7.7 Control Systems Not Required for Safety

The information in this section of the reference ABWR DCD, including all subsections and figures, is incorporated by reference with the following departures and supplements.

Figure 7.7-11 Simplified Functional Diagram of the Automatic Power Regulation System

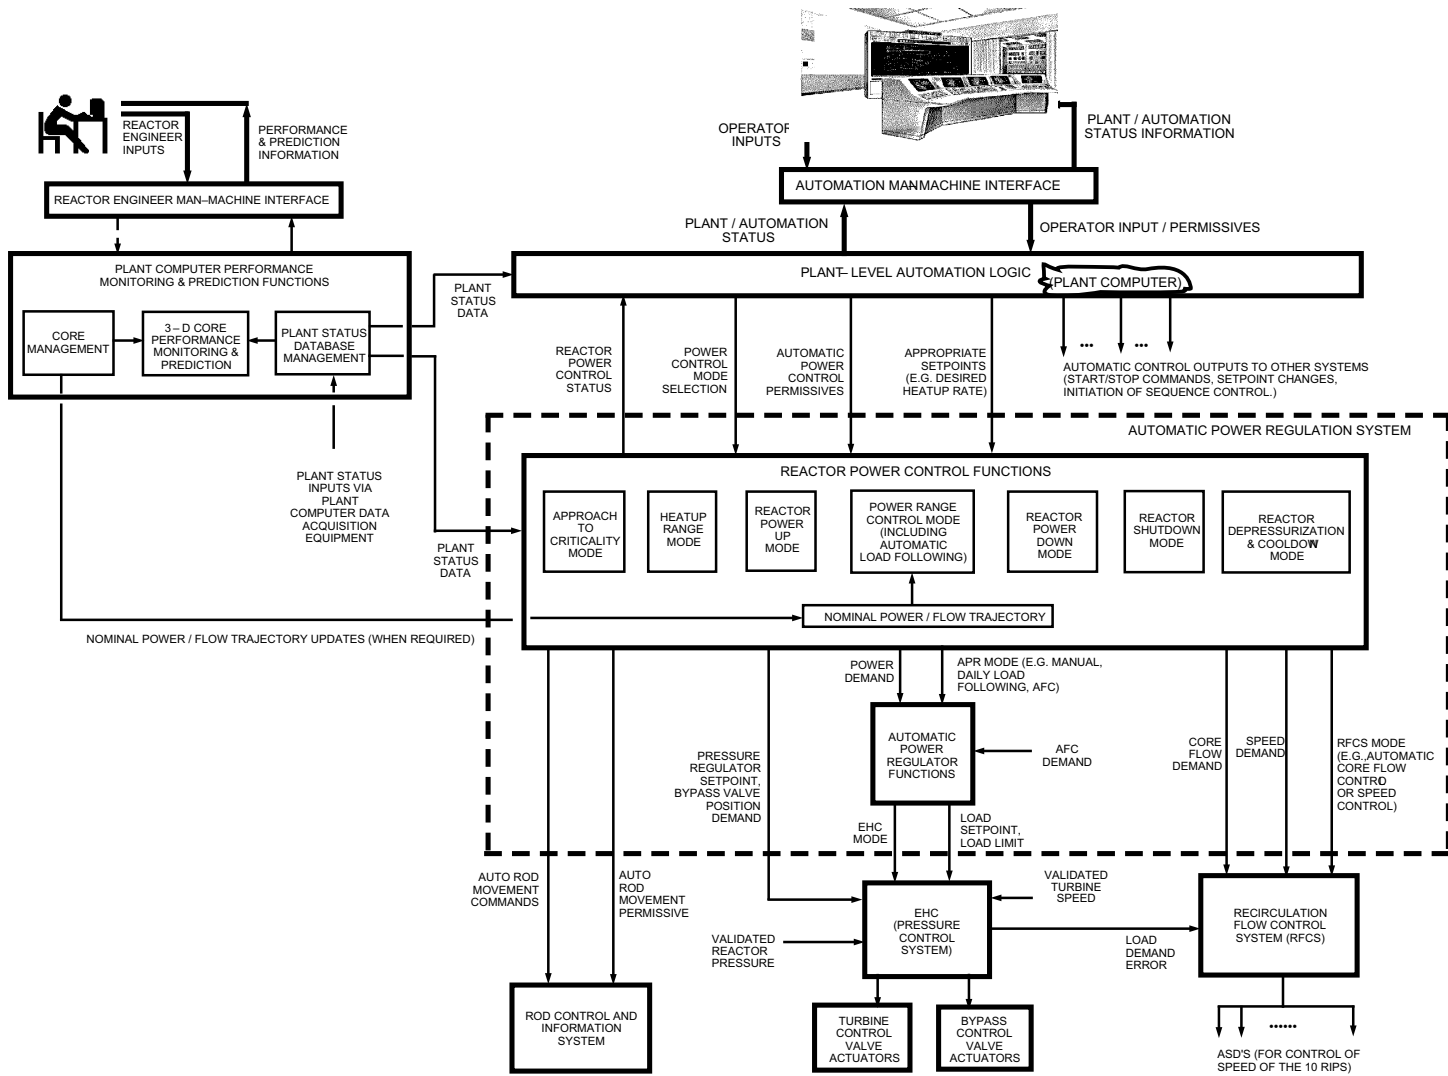
STD DEP T1 3.4-1 (Figures 7.7-4, 7.7-5, 7.7-8, 7.7-11)

Automatic power regulation is achieved by appropriate control algorithms for different phases of the reactor operation which include approach to criticality, heatup, reactor power increase, automatic load following, reactor power decrease, and reactor depressurization and cooldown. The APR System receives input from the ~~plant~~ process computer, the Power Generation Control System (Subsection 7.7.1.5.1), the Steam Bypass and Pressure Control System (Subsection 7.7.1.8), and the operator's control console. The output demand signals from the APR System are to the RCIS to position the control rods, to the RFC System to change reactor coolant recirculation flow, and to the SB&PC System for automatic load following operations. The PGS performs the overall plant startup, power operation, and shutdown functions. The APR System performs only those functions associated with reactor power changes and with pressure regulator setpoint (or turbine bypass valve position) changes during reactor heatup or depressurization. A simplified functional block diagram of the APR System is provided in Figure 7.7-11.
